## **ADDENDUM No.3**

### **JERICHO MOUNTAIN STATE PARK NEW RV CAMPGROUND**

#### **Project No. ARP 2418**

**July 9, 2024**

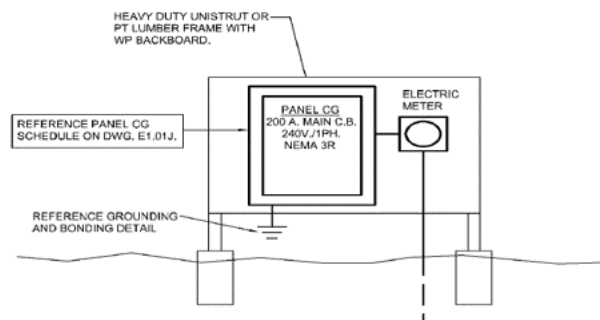
5. Question: On sheet C6.00 the pumphouse schematic shows a 400 AMP electric circuit breaker panel, but sheet E1.01J shows different.
- Answer: A 60 A. – 240V./1 Ph. service will be provided to the pumphouse. Reference electrical drawing E1.05J for wiring of pump house.
6. Question: The details for the stormwater chamber system layout differs from sheet C3.00 than the details, confirming the detail is the correct layout.
- Answer: Yes. The details show the correct layout. See Details sheets C5.04 and C5.05
7. Question: Regarding the details for heavy duty unistrut or lumber frame including footing (mounting details for Panel RV). We would like to ask for your help in providing the details/specifications/dimensions of mounting frame of Panels boards as well as the footing details on where it should be mounted. So that we can price this out much more accurate.

Answer: Provide two(2) 6"x6" pressure treated posts, a minimum of 3 ft. below grade and 6 ft. above grade. Backboard to be constructed of 2"x8" pressure treated boards, continuous over the height of the equipment. Connect 2"x8" PT board to post with (2) 4" Headlocks or equivalent lag bolts. Length of backboard to be determined by electrical contractor in the field.

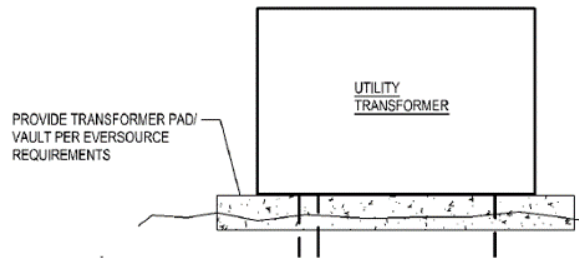
8. Question: Regarding details for heavy duty unistrut or lumber frame including footing (mounting details for Panel CG). We would like to ask for your help in providing the details/specifications/dimensions of mounting frame of Panels boards as well as the footing details on where it should be mounted. So that we can price this out much more accurate.

Answer: Provide two(2) 6"x6" pressure treated posts, a minimum of 3 ft. below grade and 6 ft. above grade. Backboard to be constructed of 2"x8" pressure treated boards, continuous over the height of the equipment. Connect 2"x8" PT board to post with (2) 4" Headlocks or equivalent lag bolts. Length of backboard to be determined by electrical contractor in the field.
